Re: DA/598/2024 - Concept Development and First Stage Of Development – Subdivision Lot 1 DP 1286424 65 Glendale Drive, Glendale NSW 2285

Northrop Consulting Engineers have been engaged by TfNSW on behalf of the Transport Asset Holding Entity to provide civil engineering services to the proposed development at 65 Glendale Drive, Glendale (Lot 1 DP 1286424). As part of their assessment, Lake Macquarie City Council (LMCC) have requested further information, described in their Request for Information letter dated 22nd August 2024 (the RFI). Northrop responses to the relevant items are provided below.

Figure 1 – Surface Drainage of Lot 32

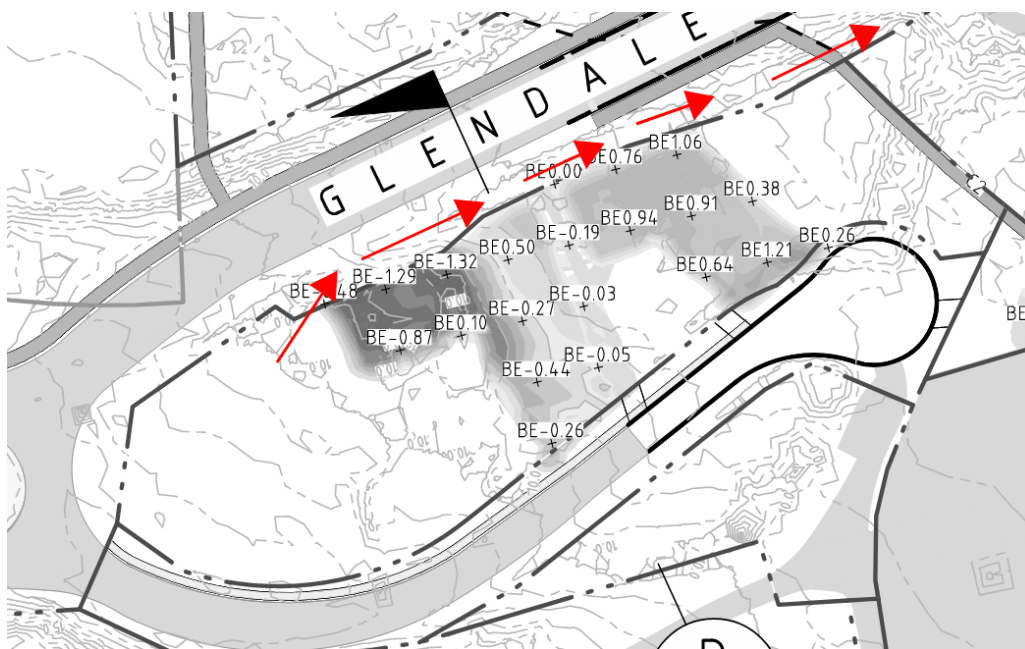
1.1 “Redesign of proposed Lot 32 shall be considered to avoid further removal of native vegetation. The lot contains vegetation mapped as EEC and is susceptible to water logging and semi-permanent water standing which may not be suitable for development. Consideration should be given avoid the development of proposed Lot 32 entirely.”

The contours in Lot 32 shows the existing surface falls towards a drainage swale adjacent Glendale Drive that the existing site naturally falls to, see Figure 1 below. No works are proposed in this swale and therefore no impact on existing hydrology.
